PREVOST

Warranty Bulletin

95-38

SHIELDS FOR TRANSMISSION'S HARNESSES

FIG. 1 - WITHOUT A RETARDER

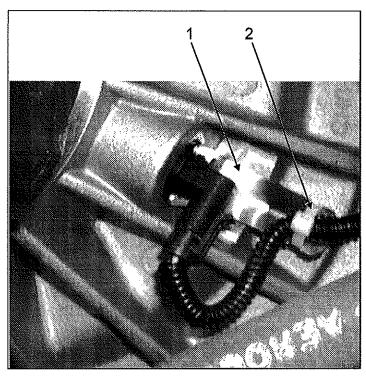
- 1. From underneath vehicle, remove the engine splash guard located on the radiator side.
- 2. Remove and discard all brackets, retaining clips and cable ties retaining both hydraulic hoses, except the bracket (and its two retaining clips) used to retain hoses to converter housing.
- 3. Locate the output speed sensor mounted on the transmission rear end, remove bolt retaining output speed sensor bracket, position bracket (1) over output speed sensor bracket (refer to Figure 2 for transmission provided with a retarder and to Figure 1 for transmission without a retarder) then reinstall bolt. Attach output speed sensor harness to new bracket (1) using a cable tie (2).

Caution: The output speed sensor bracket must be mounted in between rear end housing and new bracket (1).

Note: Depending on if transmission is provided with a retarder or not, the new bracket (1) is positioned differently.

FIGURE 3

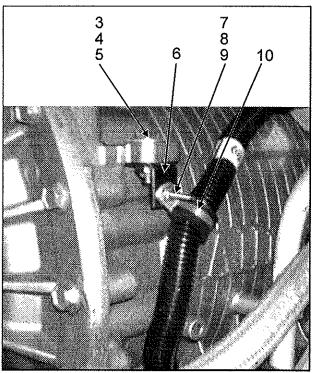
- Unscrew transmission main harness connector, separate connectors, remove nut and washer retaining main harness connector to its mounting bracket, then pull main connector out of bracket. Keep nut and washer.
- 5. Remove the two bolts retaining the main harness connector bracket, then discard bracket.
- 6. Install bracket (6) on transmission housing lug (from underside) using bolt (3), washer (4) and nut (5) (Figure 3). Secure main harness to bracket using retaining clip (10), screw (7), lock washer (8) and nut (9).
- 7. Secure transmission sensors' harness with main harness using retaining clips (10 and 11), screw (7), lock washer (8) and nut (9) (Figure 4).

FIGURE 7

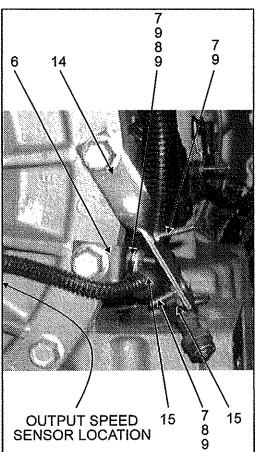
- 12. Install screw (7) and nut (9) on bracket (6) then fasten this bracket on transmission rear end as illustrated in **Figure 7**. Attach output speed sensor harness to bracket using retaining clip (15), lock washer (8) and nut (9).
- 13. Fasten bracket (14) on transmission rear end, just above the one installed in previous step 12, then install screw (7) and nut (9). The screw (7) will be used further in this bulletin to retain the transmission harnesses' shield. Secure retarder solenoid harness to bracket (14) using retaining clip (15), screw (7), lock washer (8) and nut (9).

FIGURE 8

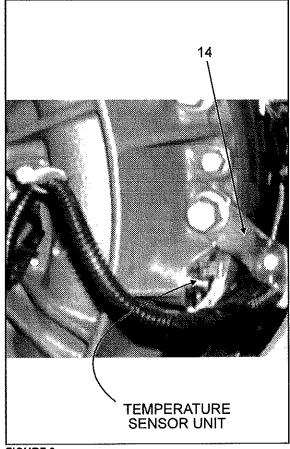
- 14. Fasten bracket (14) on retarder housing using bolt located just above retarder temperature sensor unit (Figure 8), then install screw (7) and nut (9). The screw (7) will be used further in this bulletin to retain the transmission harnesses' shield. Secure output speed sensor and retarder solenoid harnesses to bracket (14) using cable ties (not shown).
- 15. Remove bolt retaining engine speed sensor bracket, position retaining clip holder (16) over engine speed sensor bracket, then reinstall bolt (**Figure 9**). Do not tighten.

FIGURE 10

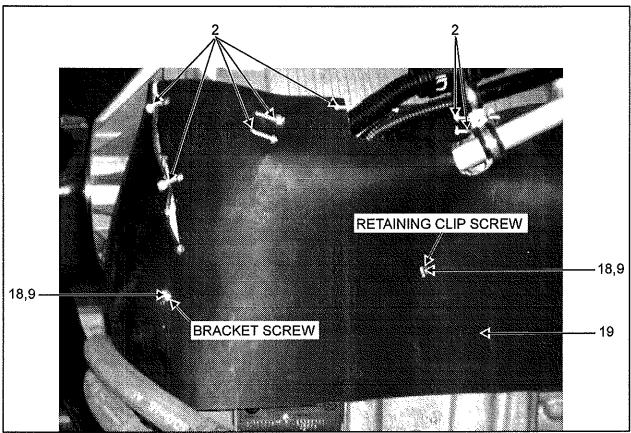
- 19. Unscrew and remove large bolt retaining hydraulic hoses' bracket to converter housing. Retain bolt.
- 20. Slide transmission harnesses' shield (19) behind both hydraulic hoses, fit shield through retaining clip screw installed in previous step 11 and through bracket screw installed in previous step 13 (step 14 for vehicle with a retarder) (Figure 10).
- 21. Secure shield to screws using washers (18) and nuts (9).
- 22. Attach transmission harnesses' shield using cable ties (2).

FIGURE 11

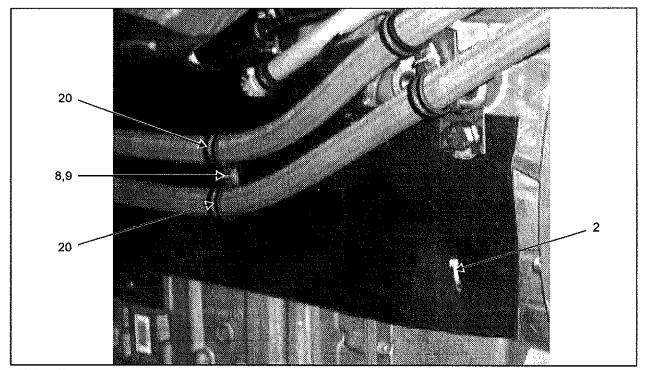
- 23. Reinstall hydraulic hoses' bracket to converter housing taking care to position shield in between converter housing and bracket (Figure 11).
- 24. Secure shield to converter housing using cable tie (2).
- 25. Secure hydraulic hoses with retaining clips (20), lock washer (8) and nut (9) using retaining clip screw installed in previous step 11.
- 26. Secure hydraulic hoses with retaining clips (20), lock washer (8) and nut (9) using bracket screw installed in previous step 13 (step 14 for vehicles with a retarder) (Figure 12).
- 27. Attach shield to hydraulic hoses using cable ties (2).

FIGURE 13

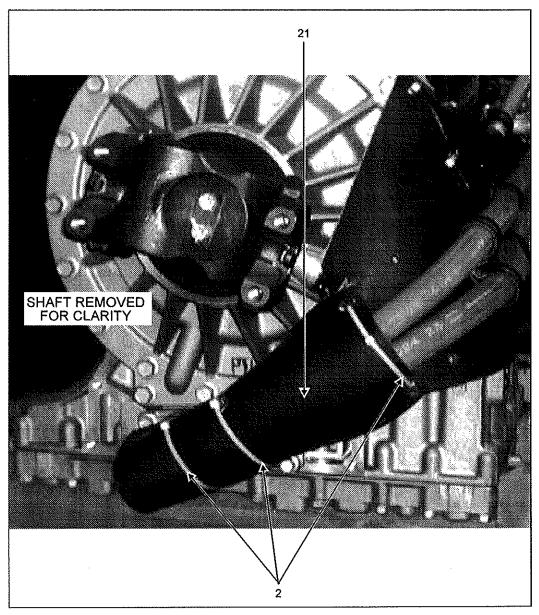
28. Position shield (21) over the section of hydraulic hoses located at rear end of transmission then secure with 3 cable ties (2) (Figure 13).
